3. Meltwater Solar, LLC - 3402 Pico Blvd. Santa Monica, CA 90405 - Discussion/Decision - Site Plan Amendment - Solar Project - 6101 Kirkville Road North - Kirkville NY 13082 - Tax Map # 071.0-02-09.0

SITE LAYOUT & MATERIALS PLAN

C-200

Pre-National Grid Site Visit

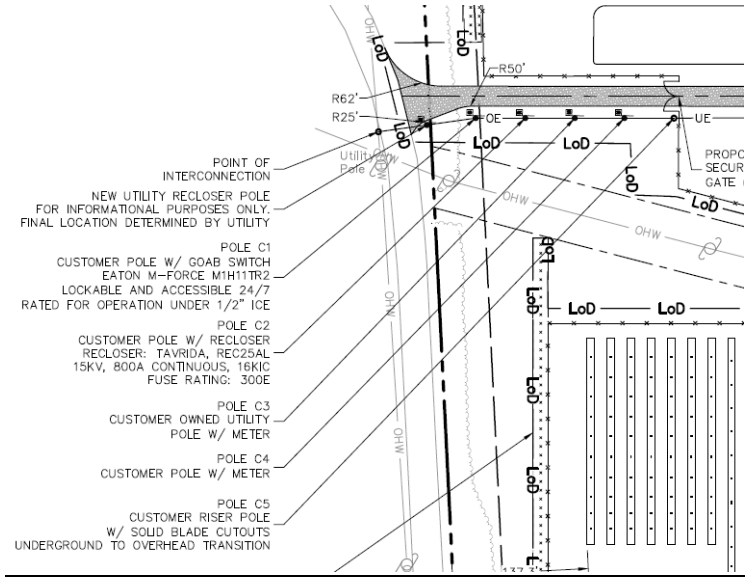
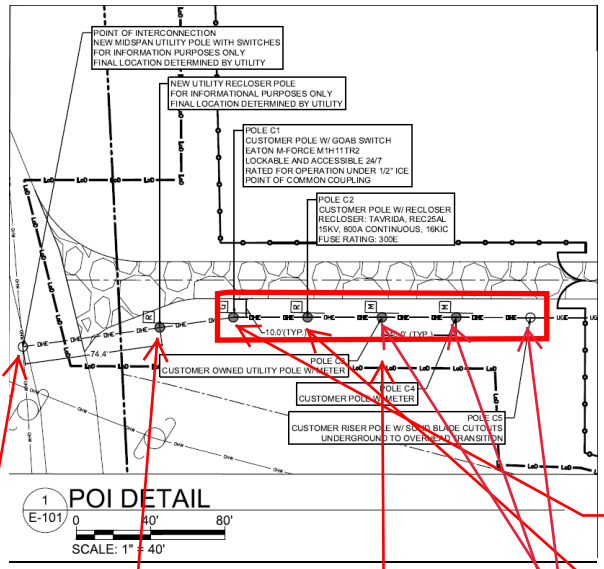
POI pole location remains unchanged.

Utility Recloser Pole location has shifted 25 ft in the eastward direction.

Pole C1 has shifted 15 ft in the eastward direction.

Pole C2 has shifted 6 ft in the eastward direction.

Pole C3 has shifted 5 ft in the westward direction.

Pole C4 has shifted 15 ft in the westward direction.

Pole C5 has shifted 25 ft in the westward direction.

Pole-to-pole spacing for these five remaining poles has changed from ~50ft to ~40ft

Note - all poles remain within the original, PB-approved "Limits of Disturbance" or "LOD" boundary (as shown in each excerpt)
